## Technical Service BULLETIN

### WHISTLE/HOOT NOISE FROM AUTOMATIC TRANSAXLE

'03 – '08 Corolla (1ZZ-FE)

REVIS  
TC012-05  
TRANSMISSION & CLUTCH

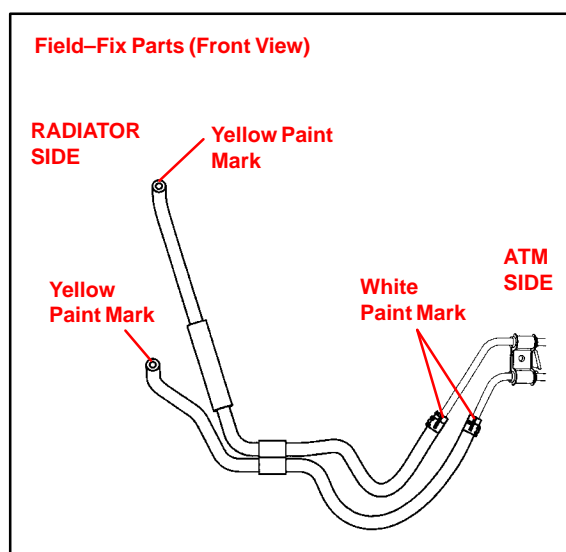
3. Install the replacement service parts per the instructions below.
  - A. Orient the yellow and white paint marks as shown in diagram (yellow towards radiator, white towards ATM) and install hose to tube.
  - B. Insert hose securely to stopper of radiator tube and cooler tube.

When installing, make sure no foreign matter enters tube and hose. When hose is fixed to the clamp, tube should not be bent and hose should not be twisted.

- C. While turning stopper of clamp fitting to radiator support, tighten oil cooler hose clamp to the following specifications:  
**Torque: 5 N•m (4 ft•lbf, 5.5 kgf•cm)**
